# London Airspace Management Programme 2, Deployment 1.1

Step 4A: Update Design:  
Consultation Response Document

Figure 1 Arrival and Departure procedures for Severn Group: Proposed and Revised Designs

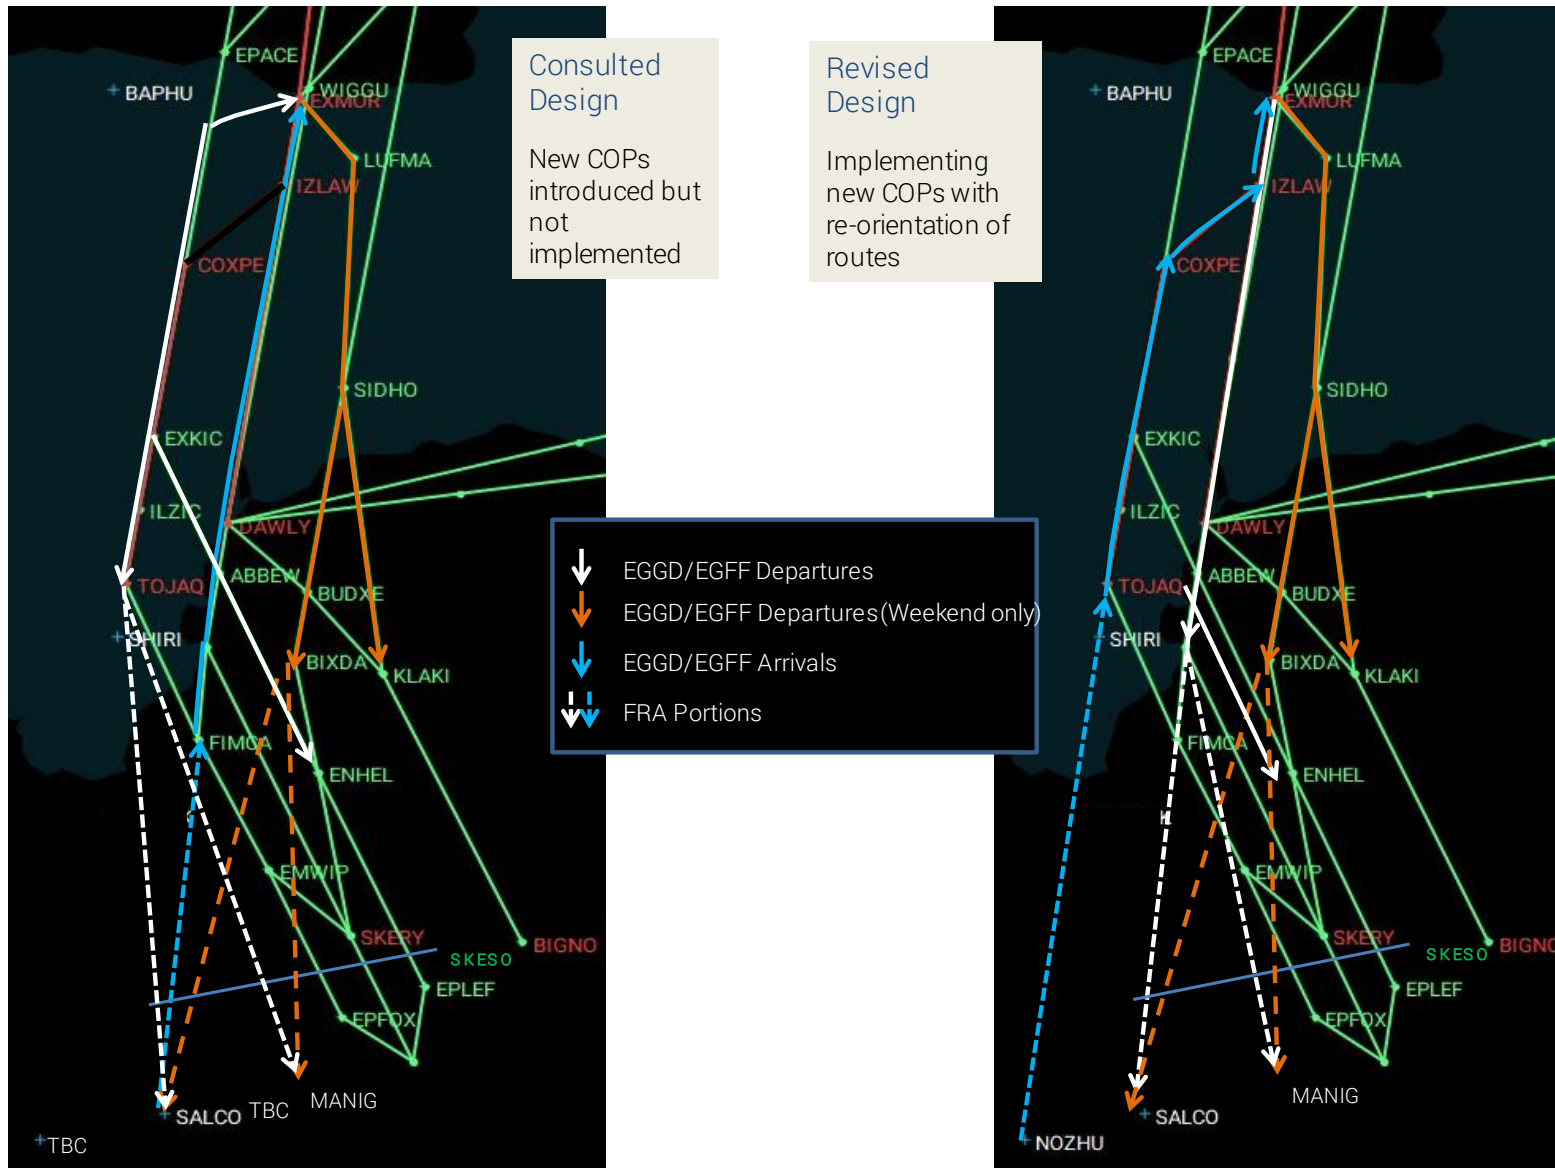
Implement new COP NOZHU (west of SALCO on FIR boundary) for northbound traffic only and designate SALCO for southbound only traffic.

Reorientate arrival/departure routes from Severn Group airports, as shown in **Error! Reference source not found.** below. This requires amendments for the Bristol and Cardiff arrival procedures (STARs) from the south.

- Departure flow is southbound from EXMOR via N864, instead of P16.
- Arrival flow maximises FRA to SHIRI/TOJAQ, tracking the same profile as P16 (to COXPE).
- Introduce a new STAR for Bristol and Cardiff RNAV1 traffic, commencing at TOJAQ (TOJAQ 1B & TOJAQ 1C). Tracks P16 to COXPE, where it joins IZLAW.
- Retain current DAWLY 1B and 1C STARs for RNAV5 only traffic (Figure 2).

Figure 2 Arrival procedures from the south for Bristol and Cardiff, proposed and revised STARs

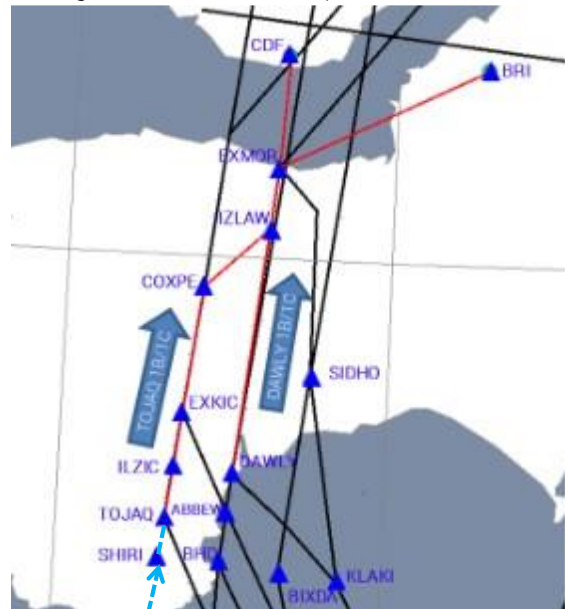
Traffic from the south arrives via current DAWLYB & DAWLY 1C RNAV5 STARs

Via Route 'X' - BHD - DAWLY - TINAN - TIVER - IZLAW - EXMOR - BRI/CDF

Maximise FRA to SHIRI/TOJAQ. New RNAV1 STARs (TOJAQ 1C/TOJAQ 1B) track P16 to COXPE.

TOJAQ - COXPE - IZLAW - EXMOR - CDF/BRI

DAWLY 1B & 1C STARs remain as current (RNAV5 traffic only) routing SKESO - BHD - DAWLY).

Figure 3 Re-orientating the traffic flows reduces the amount of controlled airspace required

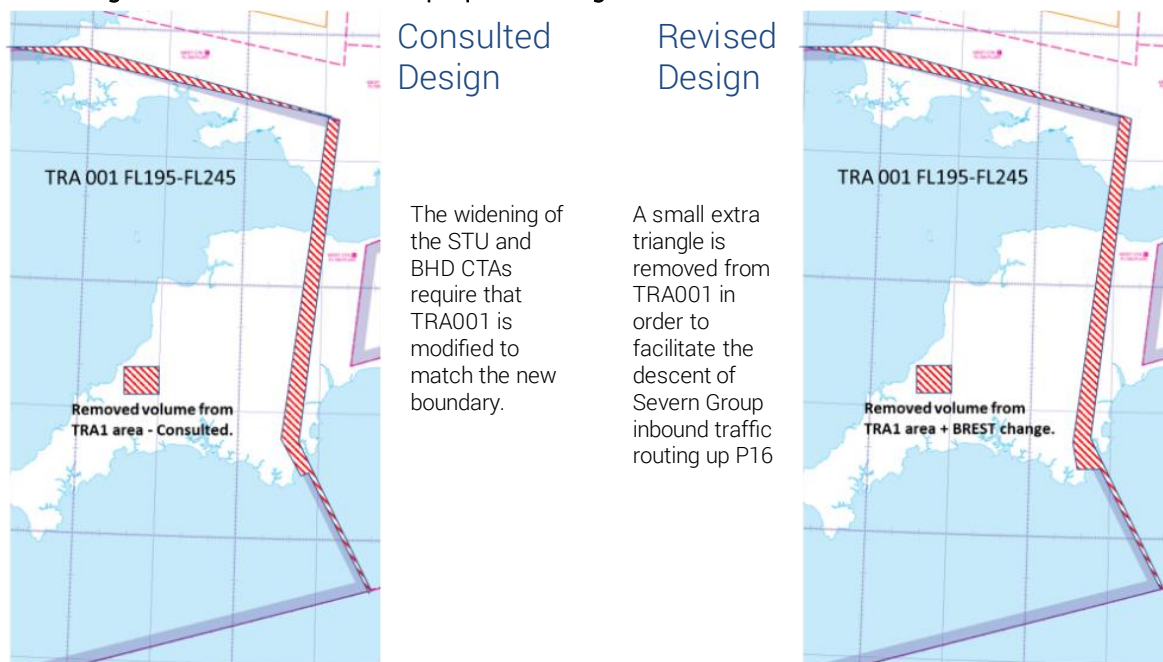
- New BHD CTA base FL75.
- Revised BHD CTA 5 base FL85, increase in lateral size.
- New BHD CTA base FL95.
- Revised BHD CTA 4 and 5. CTA 5 southern portion base raise from FL85 to FL105. Increase in lateral size. revised hours - additionally active Mon-Thu 1600-0745 winter (1hr earlier in summer).
- New BHD CTA base FL125.

- Revised BHD CTA 5 base FL85\*, increase in lateral size.
- New BHD CTA base FL145.
- Revised BHD CTA4 (reduction in lateral size) and new CTA west of BHD CTA1.

\* The base level of the southern section has been reviewed separately based on consultation feedback - see Topic 2 below.

Figure 5 Revised design for BHD CTA showing amendments to CTA 5 base levels

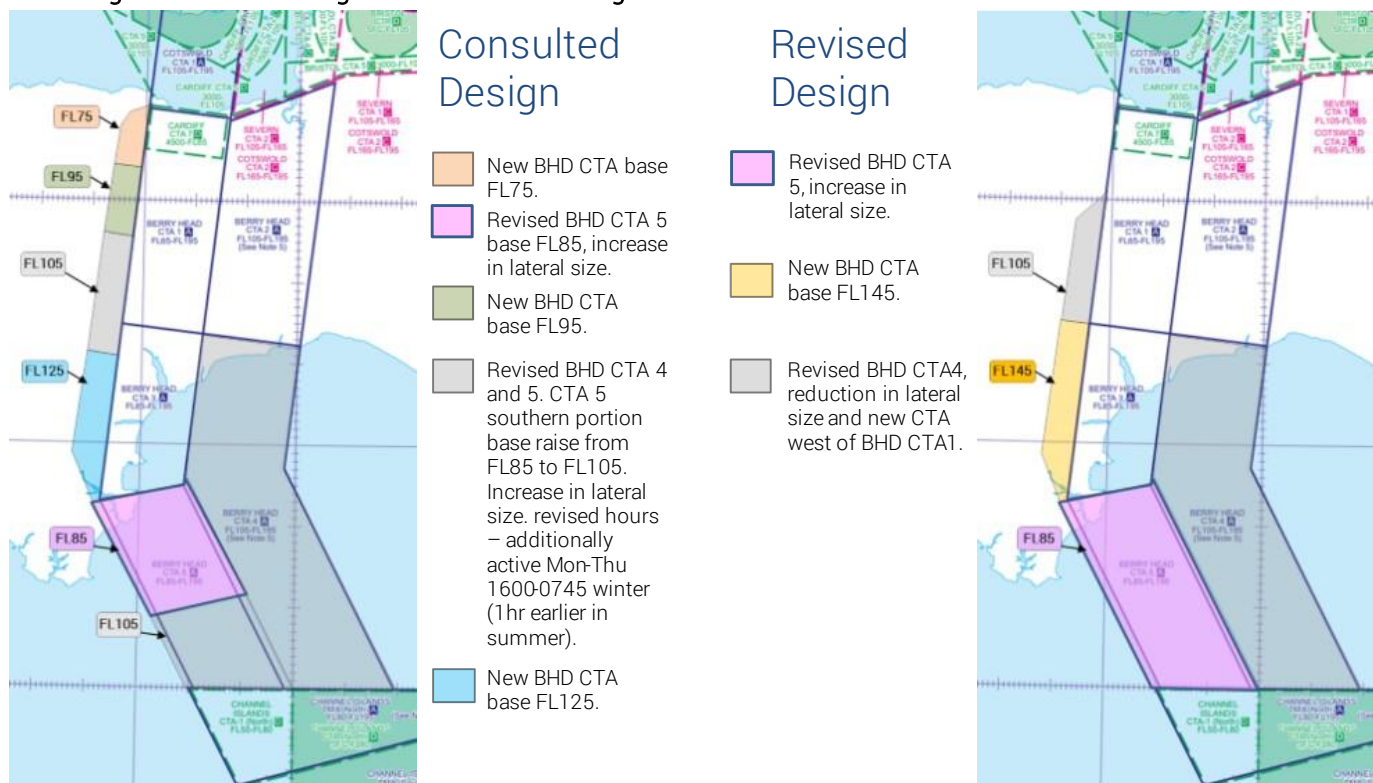
In the consultation material we proposed to raise the southern portion of CTA 5 from FL85 to FL105. Consultation feedback requests that the base of BHD CTA 5 remains at FL85 and is not increased to FL105, to retain connectivity for unpressurised aircraft active in this area.

Base of BHD CTA 5 remains at FL85, as shown in Figure 5 below, and as per current day.

We have considered the feedback of our stakeholders and have amended the proposed design to retain the base level of CTA 5 at FL85, in order to facilitate better connectivity for unpressurised aircraft operating in this area.

Fig 1. NITON CTA 9/New CTA

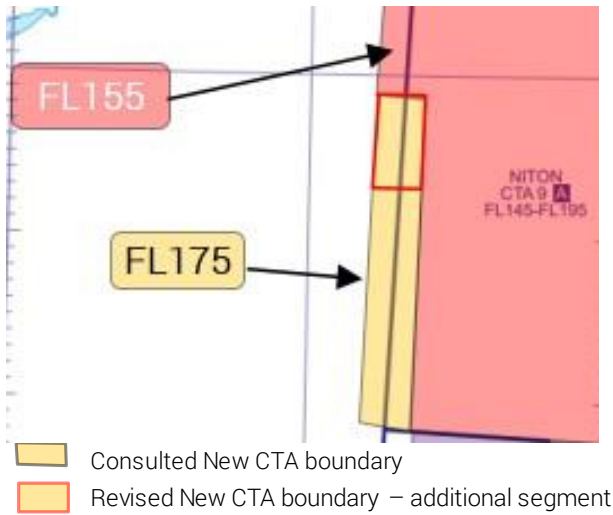
CAS being changed	Consulted change	Amended change and impact
1	NITON CTA 9/ New CTA	Additional FL175 fillets added centrally on the eastern and western sides.	Small lateral extension to FL175 fillet on western side, as shown in Fig 1. Reduces the amount of CAS at FL155.
2	Cotswold CTA 17	No change identified.	Lateral realignment in accordance with increased lateral areas of revised NITON and Cotswold CTAs, as shown in Fig 2.
3	Cotswold CTA 7	Lateral increase north, base lowered to FL95.	Increase in size to northeast by approx. 4nm <sup>2</sup> required for containment of route N14. Leads to small reduction in size of Daventry CTA 15 volume.
	Daventry CTA 15	No change identified.	Small lateral reduction linked to change above, as shown in Fig 3.
4	Cotswold CTA 9	Lateral reduction in width on west side. Base raised from FL95 to FL105.	Small lateral extension (>1nm) to the east, required for containment of route P69. Reduces the size of CTA 11.

Fig 4. Cotswold CTA 9/11

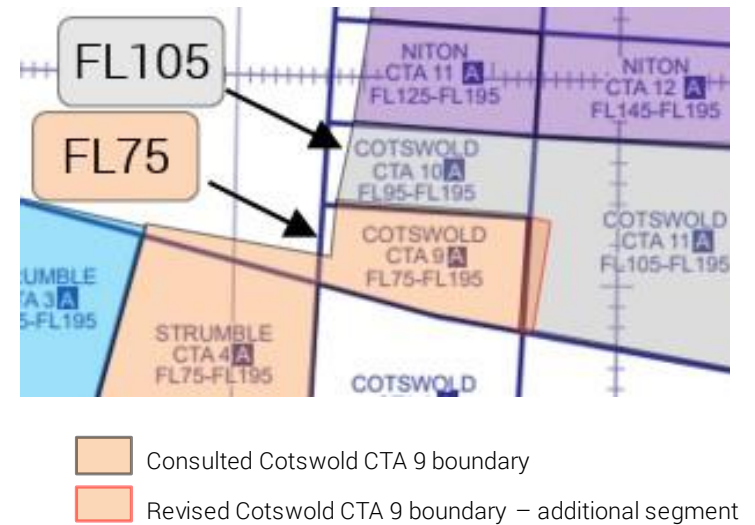
Cotswold CTA 11	Lateral increase in width to the east.	Small lateral reduction to west linked to change above, as shown in Fig 4.

**Figure 7 Proposed new hold OCTIZ on route P2**

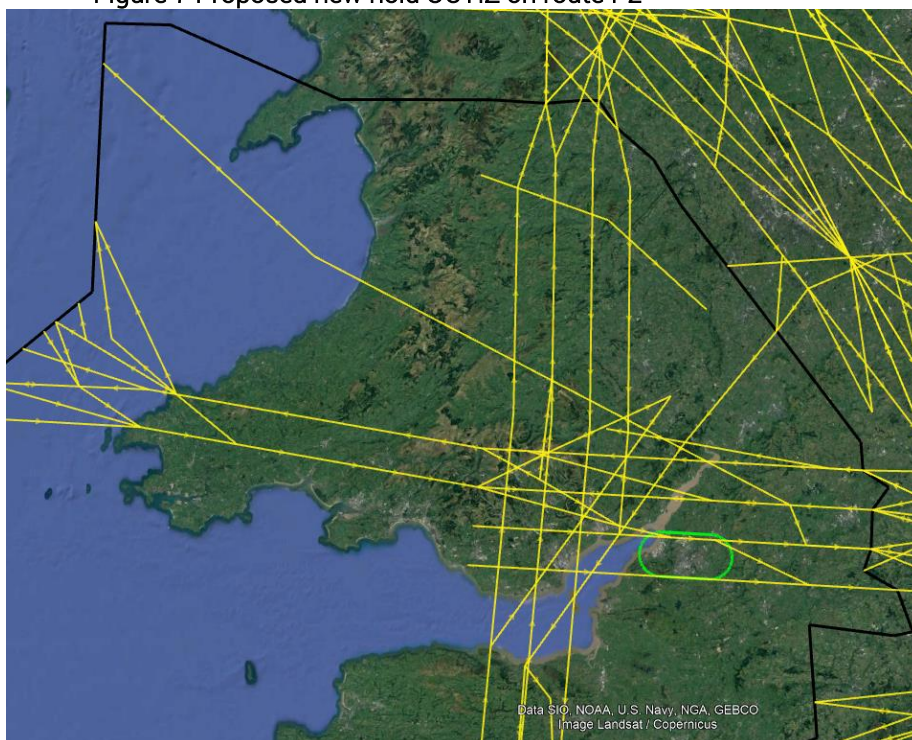
Following validation simulations, the UA19D hold remains but is renamed OCTIZ, is LEFT turn only, and retains the flight levels of the current OKESI hold. There is no longer a requirement to publish a hold at the proposed point DURIN, so this has been removed. Table 9 summarises these amendments; Figure 7 shows the new hold OCTIZ.

Diagram D

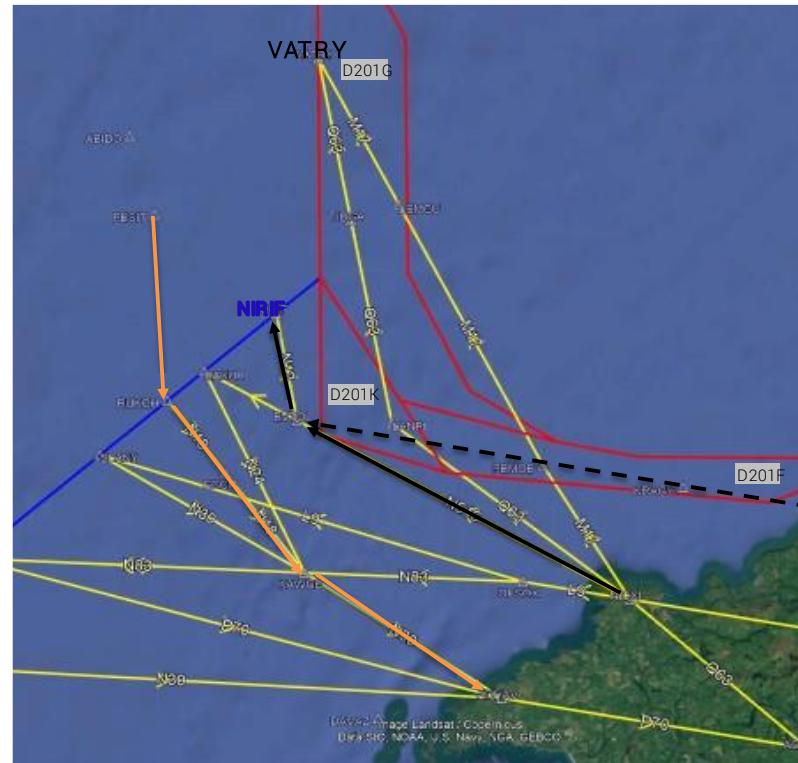
When D201G is active above FL145; and D201F is inactive or only active up to FL145, Dublin arrivals route PEMOB - EVTOL - NIRIF and join to the existing VATRY STAR (connectivity to be delivered by the IAA) (Diagram D).

When D201G is active, but D201F is inactive, Dublin arrivals can route NICXHN546-EVTOL-N12-NIRIF (<FL245) or PEMOBEVTOL-NIRIF (FRA; <FL245) to join the existing VATRY STAR (connectivity by IAA).

Diagram E

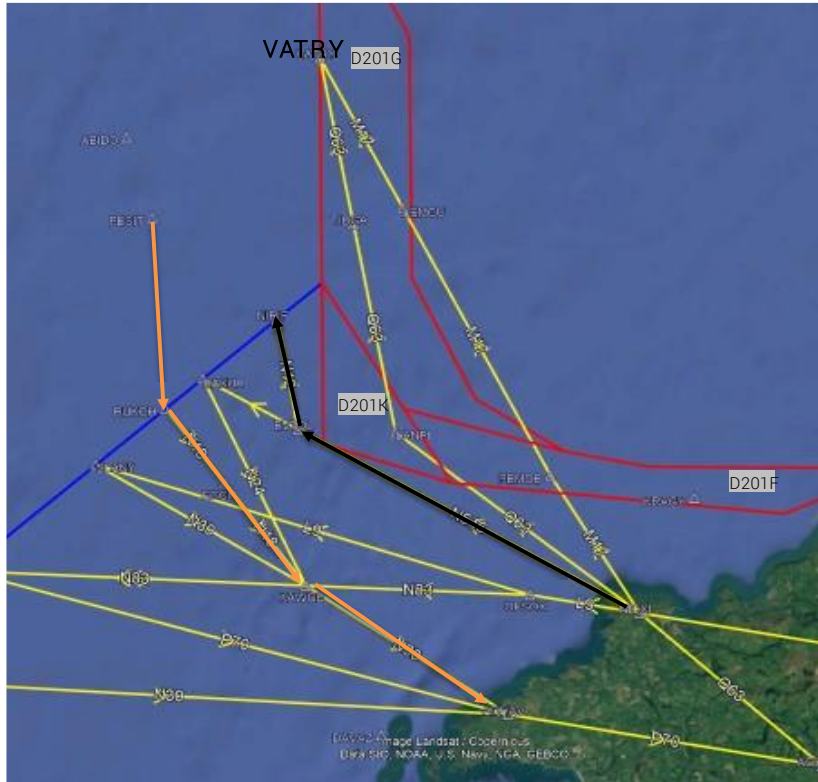
When D201F is active above FL145, Dublin arrivals route NICXI-N546-EVTOL-N12-NIRIF (>FL245) or PEMOB-EVTOL-NIRIF (FRA; <FL245) and join to the existing VATRY STAR (connectivity to be delivered by the IAA) (Diagram E)

When D201F is active above FL145, Dublin arrivals can route NIGXI N546EVTOL-N12-NIRIF to join the existing VATRY STAR (connectivity by IAA). FRA routings would route NICXI - EVTOL - NIRIF
